SERVICE DIRECTIVE BULLETIN NO. 0084

Revision 2

1. SUBJECT: Muffler Modification and Inspection
2. MODEL: F-28F, 280F, and 280FX
3. EFFECTIVITY: All serial numbers equipped with the optional muffler assembly, P/N ENX-0001.
4. BACKGROUND:

Figure 1: Muffler Modification

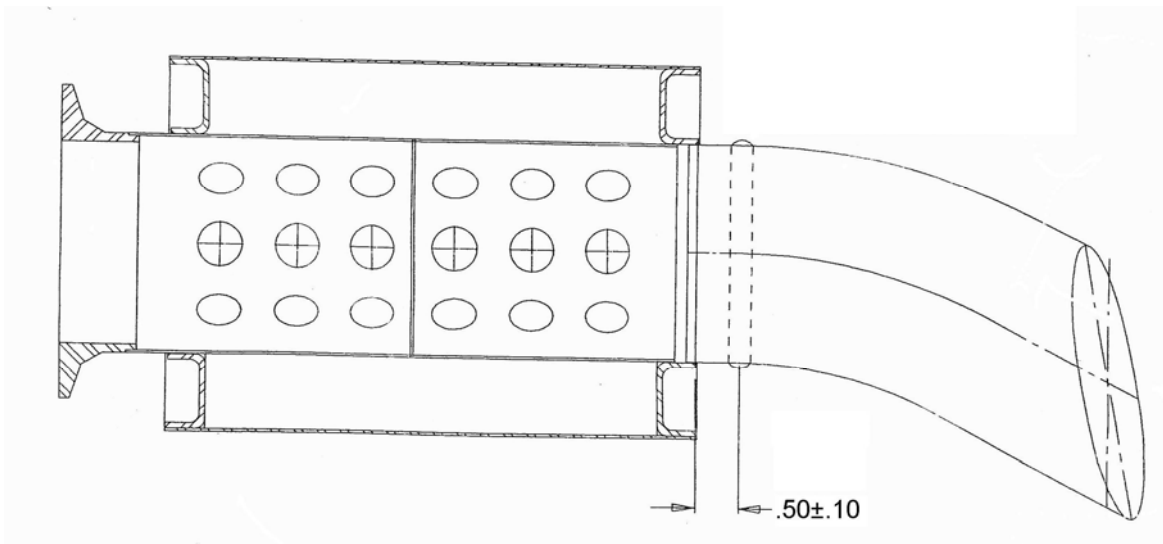
1. Remove the muffler from the aircraft.
2. Modify the muffler in accordance with the instructions below. Note: Instructions are also provided with the modification kit, P/N ENX0001R.
 - a. Drill two holes, 0.25" diameter, 180 degrees apart, as shown in Figure 1, for the 0.25" diameter rod. (The radial location around the tailpipe tube is optional.)
 - b. Install the rod through the tailpipe tube ensuring the rod ends are positioned in the hole openings. TIG-weld each rod end to the tailpipe tube using the kit-supplied welding rod.
3. Reinstall the muffler.
